# US1000 Module

US1000 Module	
SK, AH / ULSI Solution Oy 2014	
TITLE: vs1kmod161	
Document Number:	REV: 1.61
Date: 10/20/2014 11:41:01	Sheet: 1/1

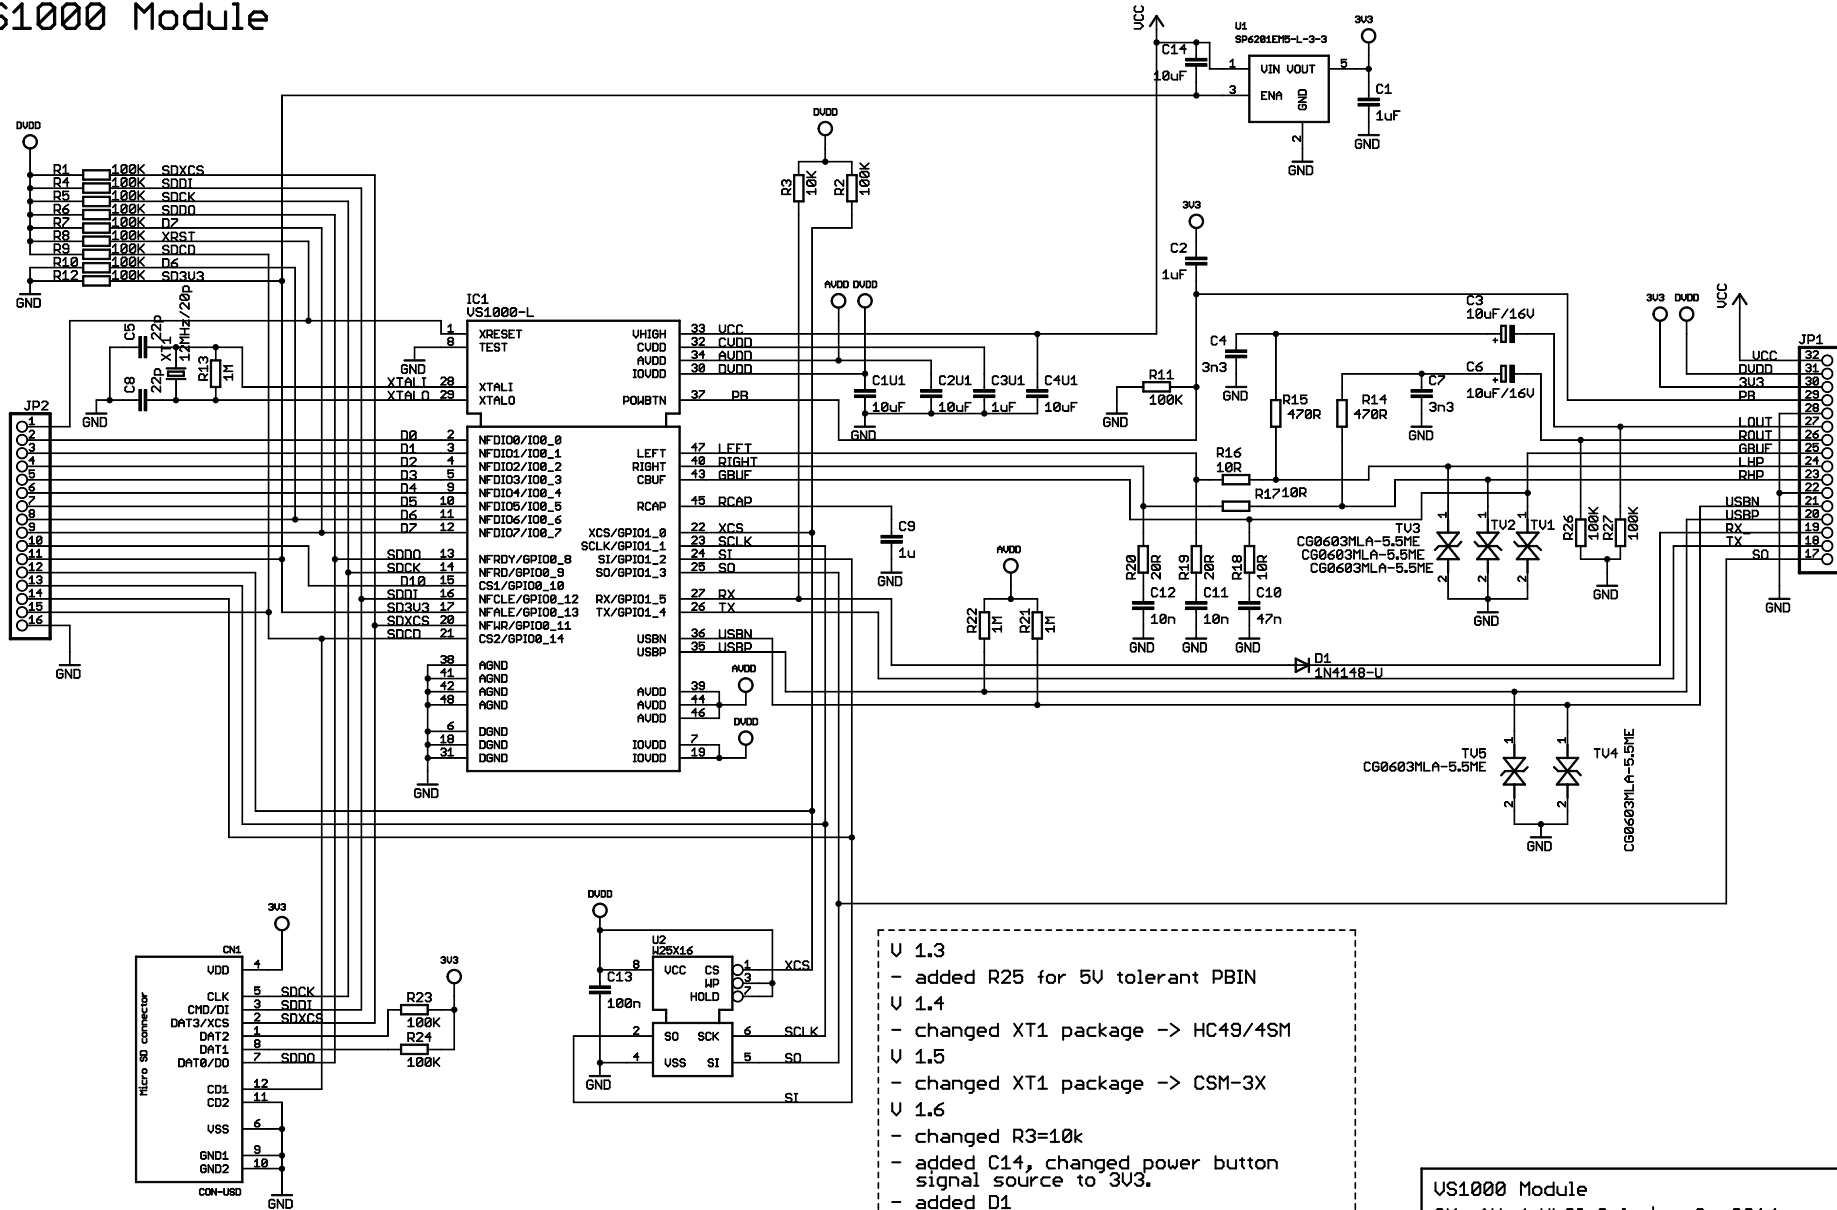
- U 1.3
- added R25 for 5V tolerant PBIN
- U 1.4
- changed XT1 package -> HC49/4SM
- U 1.5
- changed XT1 package -> CSM-3X
- U 1.6
- changed R3=10k
- added C14, changed power button signal source to 3U3.
- added D1
- U 1.6.1
- changed C14=10uF
- changed C5,C8=22pF
